ADDENDUM NO. 2

PROJECT: Indiana School for the Deaf, Building 8 HVAC Renovation
DAPW PROJECT NO: 49026008-20-040
R&B PROJECT NO: 2148-02
DATE: 10/26/2022

Indiana School for the Deaf, Building #8 HVAC Renovation

DRAWING NO.: M201

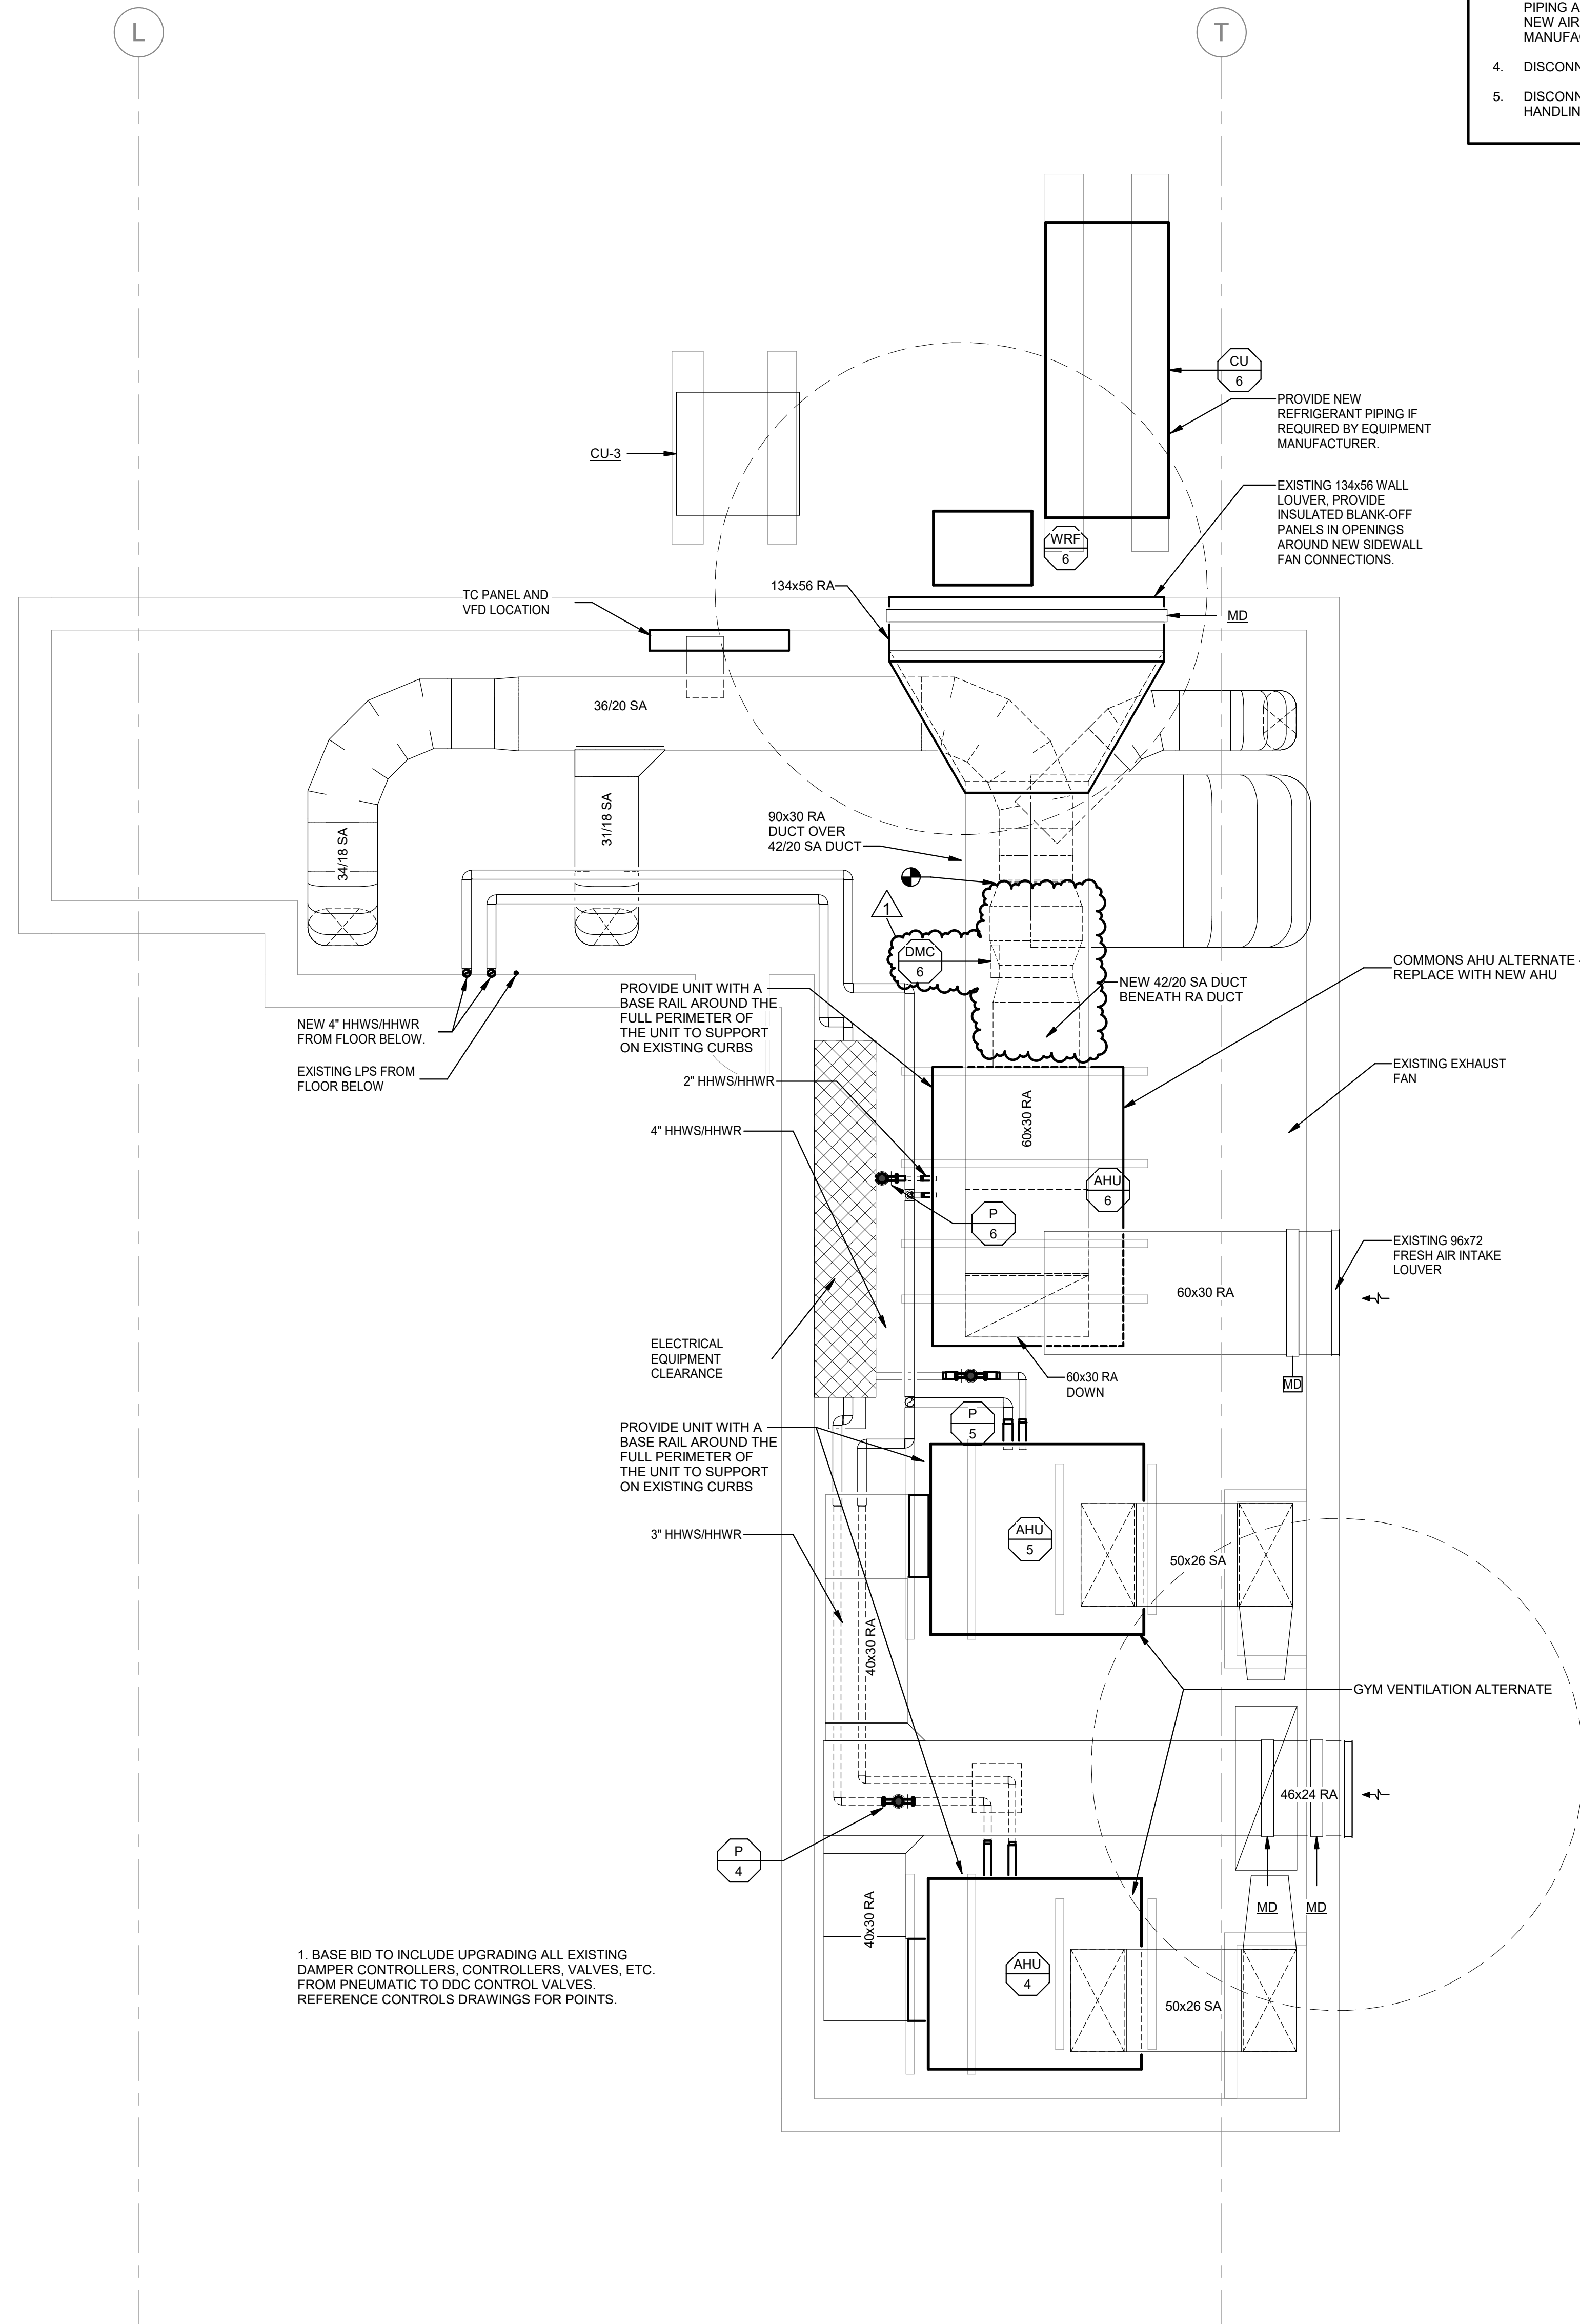
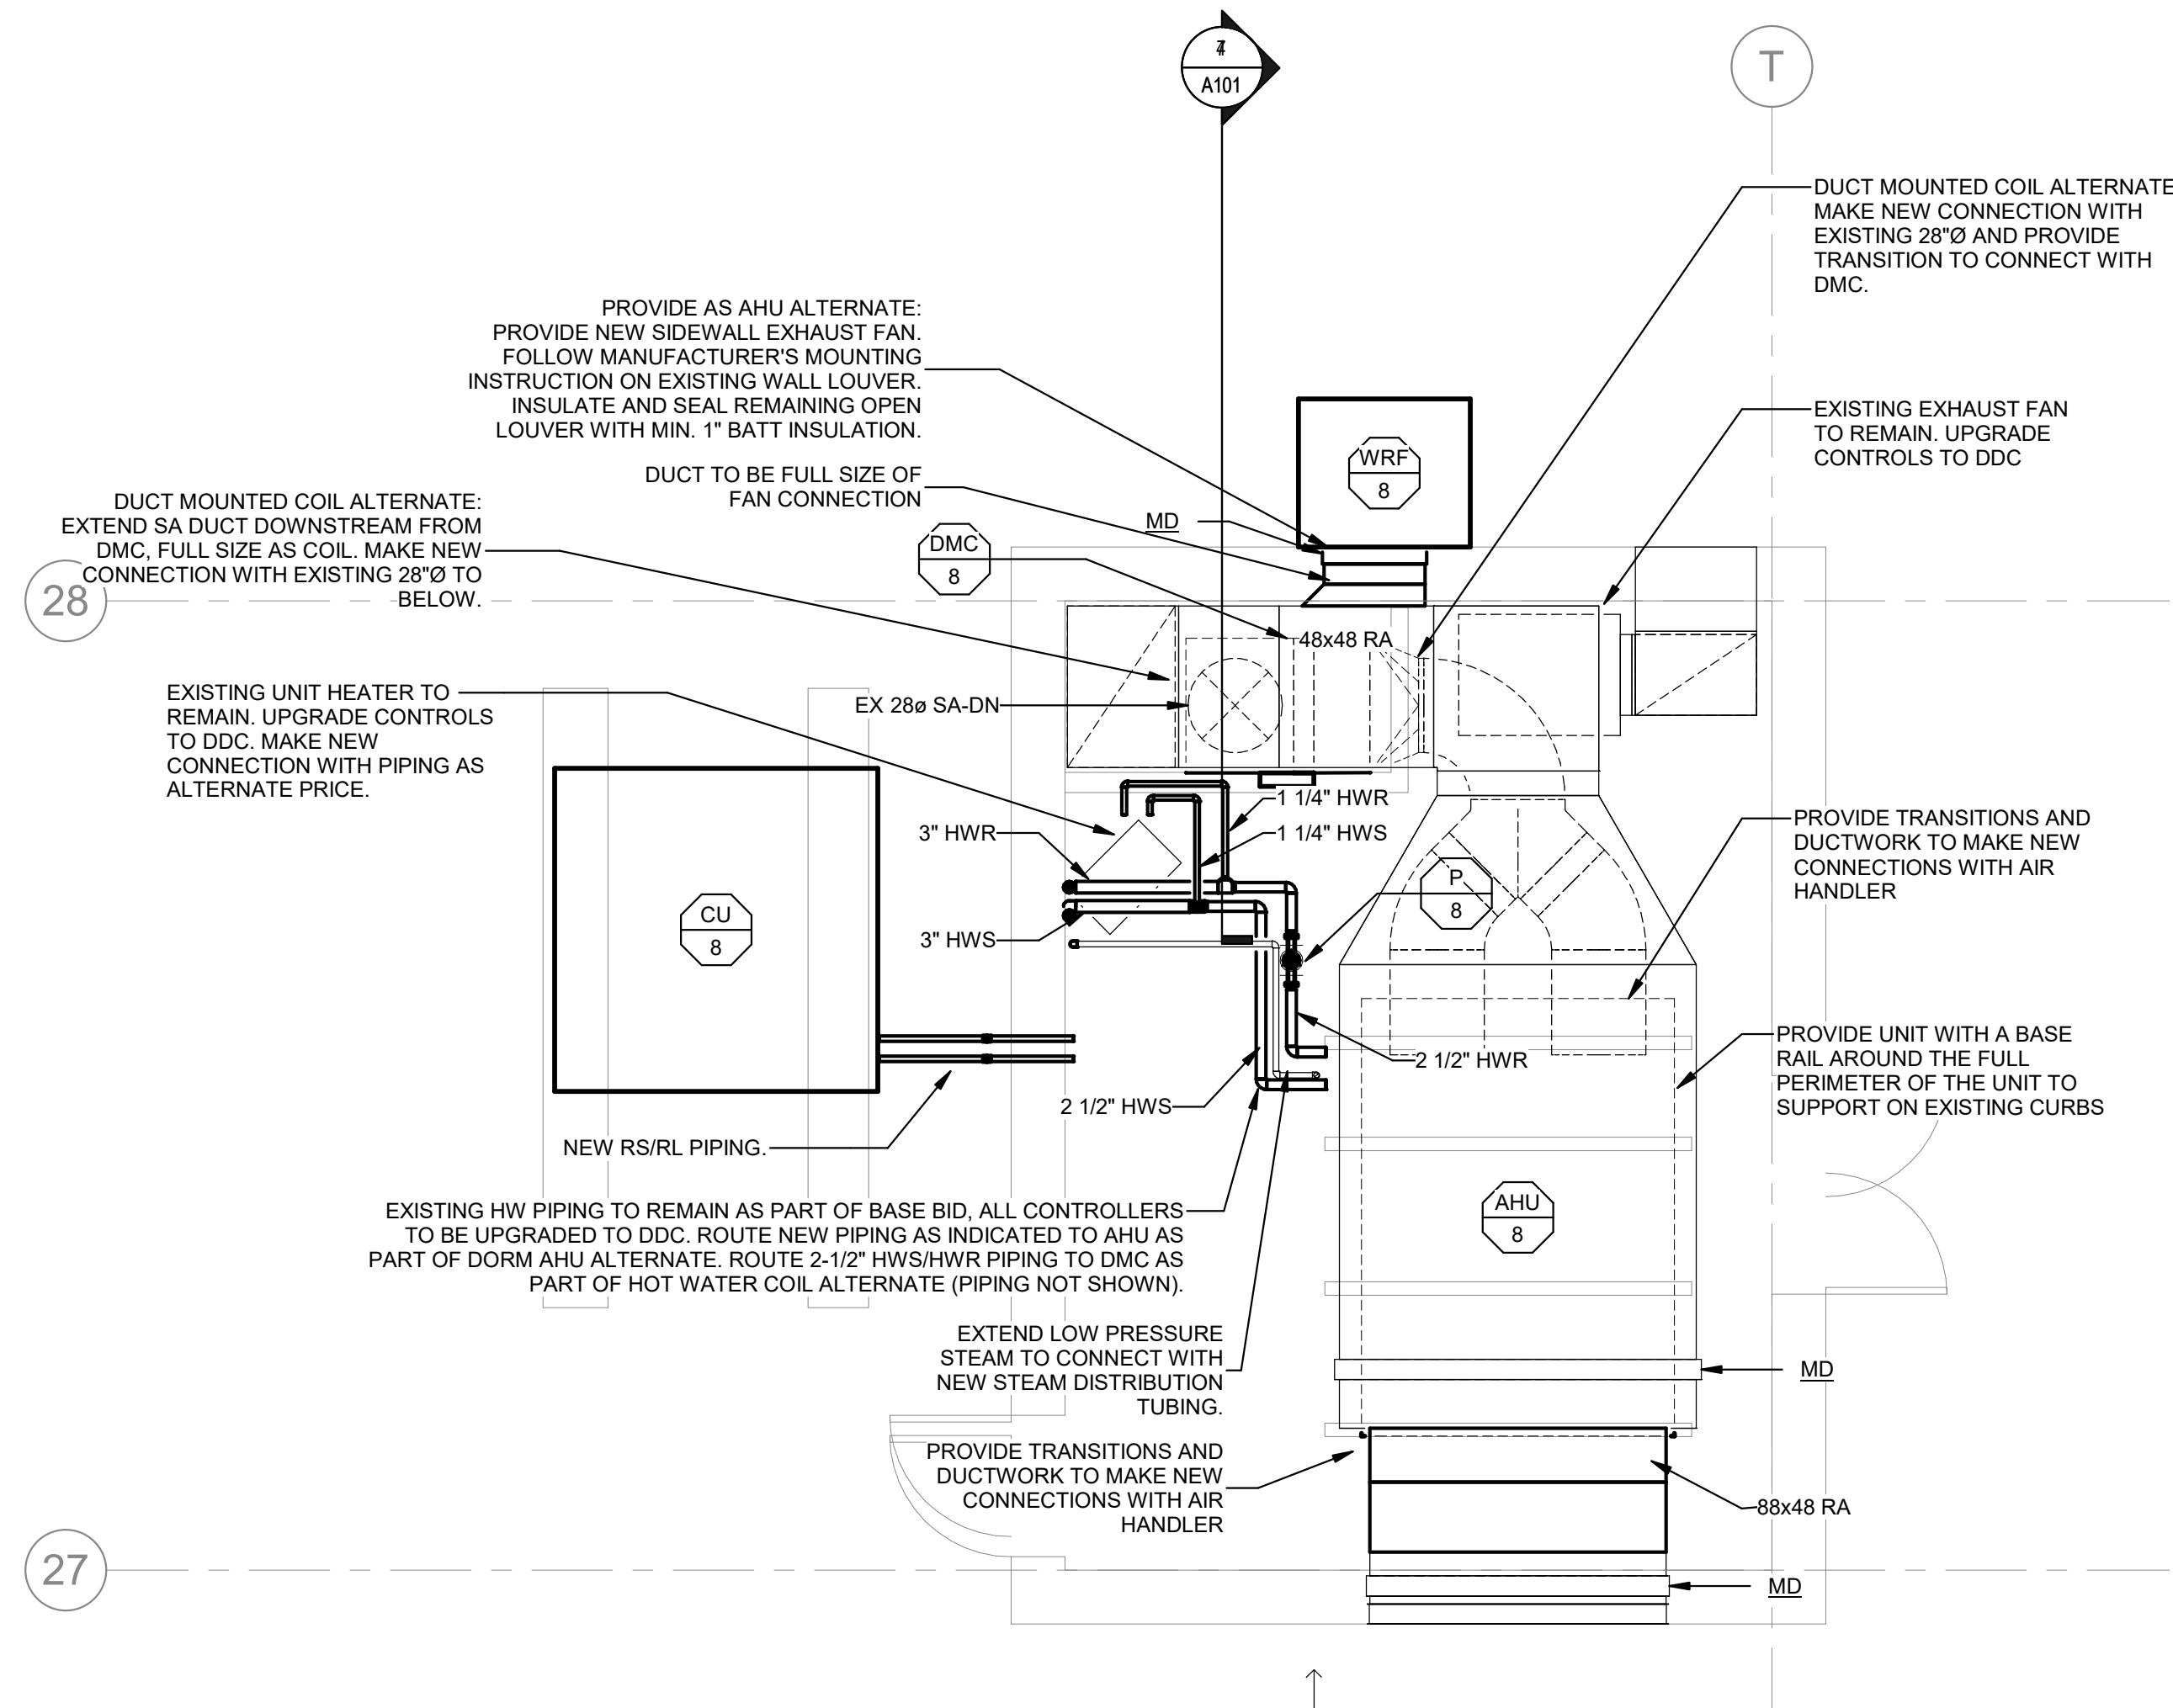
1. Cover Sheet:
 - a. Updated alternate #1 to add CSAC-6 scope for the installation of DMC-6.
2. MD114B:
 - a. Added additional demo scope for CSAC-6 for alternate #1 to be able to install DMC-6.
3. M201:
 - a. Added DMC-6 to the SA ductwork from CSAC-6 for alternate #1
4. M601:
 - a. Added the Duct Mounted Coil Schedule.
